Minutes of Meeting

Doc.-No.: HP-2-ASED-MN- 0027

Subject: SPIRE Cryo harness - Information exchange Meeting

SPIRE JFET RACK
22/10/2001
RAL

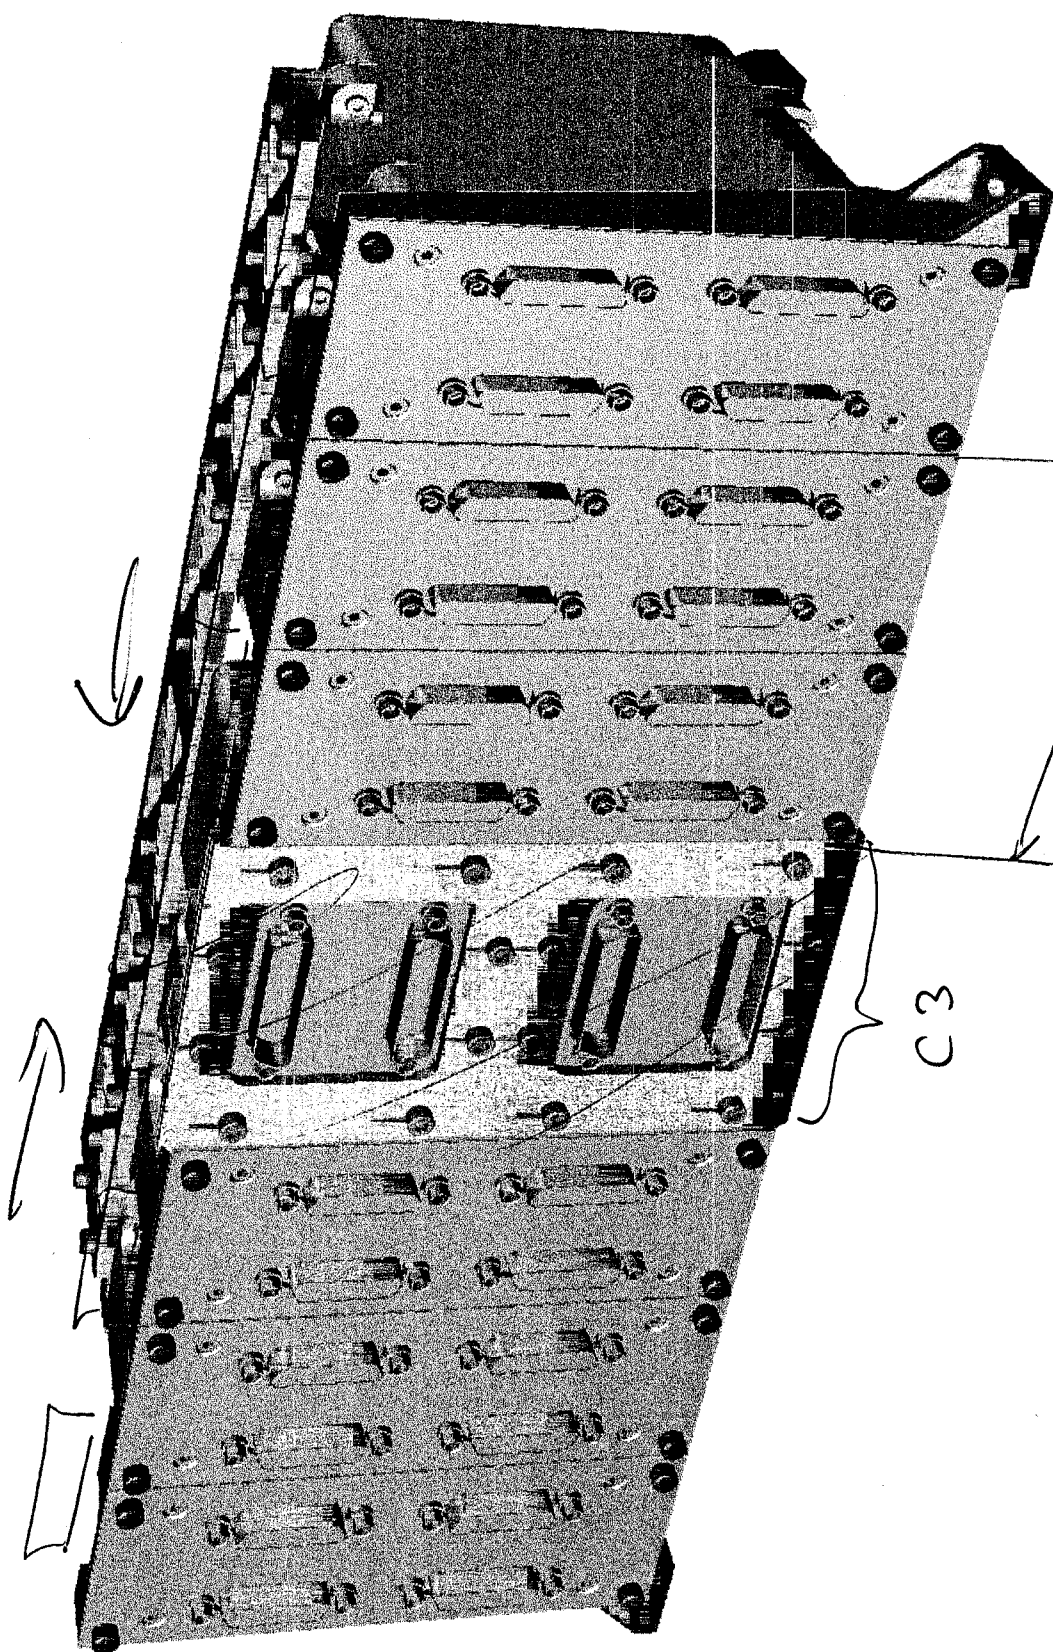
Ref	Section	Comment	Disposition
JD5	Figure 5.3-1	Put in something vaguely up to date like
